## CONSTRUCTION SUMMARY

Summer Ridge Estates Inc.

| LOT NUMBER    | PHASE | HOUSE TYPE                     | CLOSING DATE |
|---------------|-------|--------------------------------|--------------|
| 004 BLOCK 289 | 1     | DESERT ROSE (25-01-A1) ELEV A1 | 20-Nov-25    |

Invoice Number: 8763

Cable - (x2)  
Telephone - (x2)  
Conduit (xi)

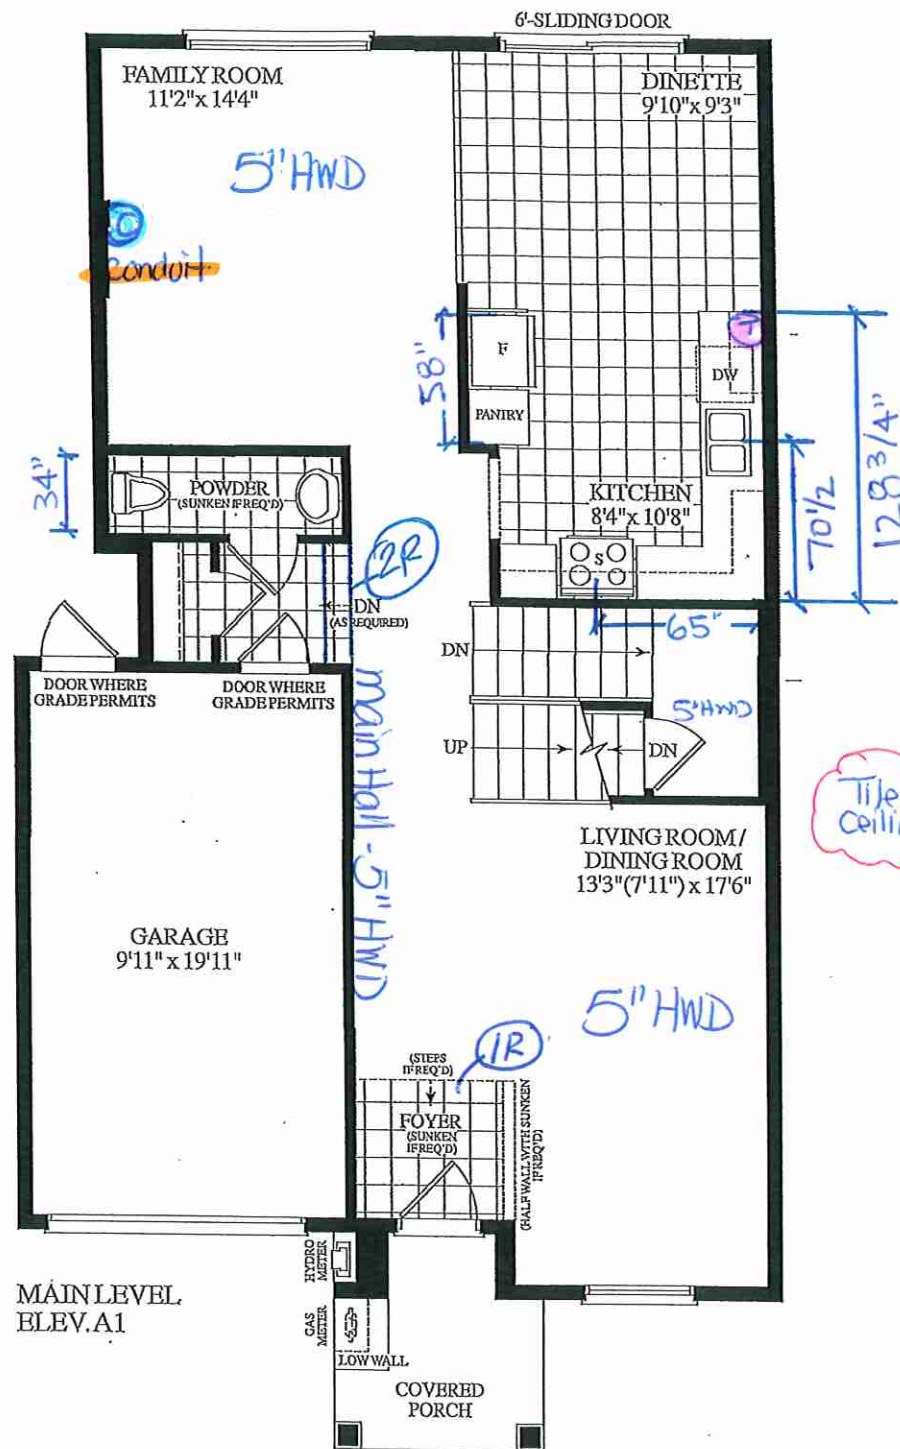
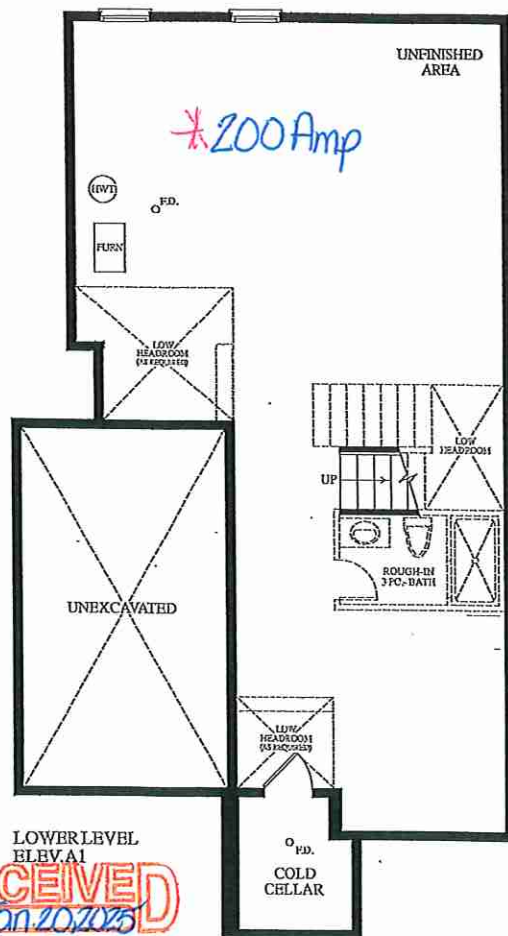
1 - Install Standard Cable Rough-Ins (x2) and Install Standard Telephone Rough-Ins (x2) (See Sketch)

## EDGE DETAILS

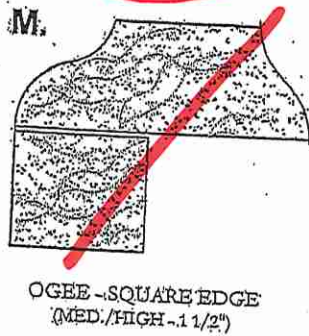
1 - KITCHEN - COUNTERTOP EDGE - Install UPGRADE " L " EDGE PROFILE - To be installed throughout kitchen countertop, where applicable (See Sketch)

## KITCHEN PLAN

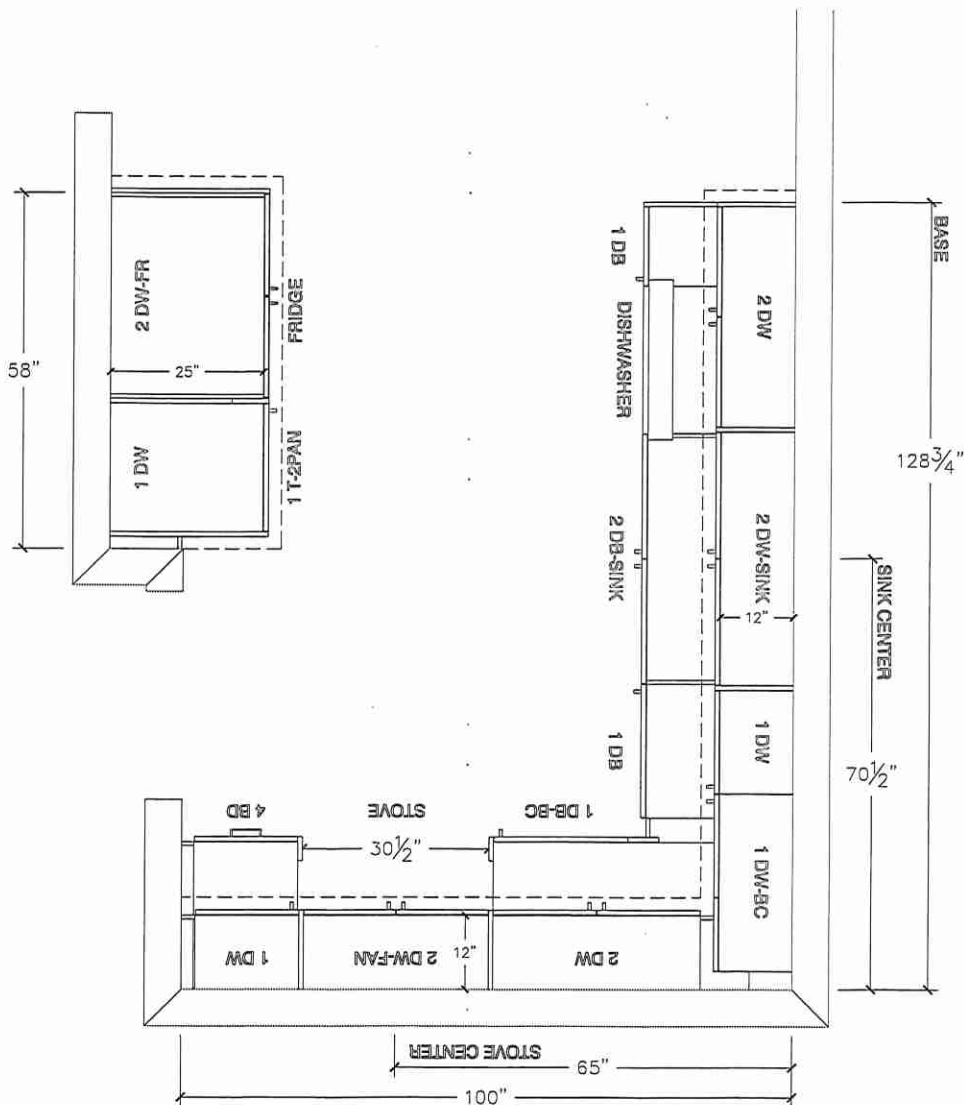
1 - KITCHEN & BATHROOMS - Purchaser has DECLINED All Upgrades offered during decor appointment at the decor centre for kitchen & bathroom cabinetry. Standard Kitchen Layout & Standard Bathroom Vanities to be installed as per standard plan. (See Sketch)

1 - KITCHEN - COUNTERTOP - Install UPGRADE #2 Stone Countertop – EVEREST WHITE SHIMMER - To be installed throughout kitchen, where applicable (does not include stone backsplash) (See Sketch)
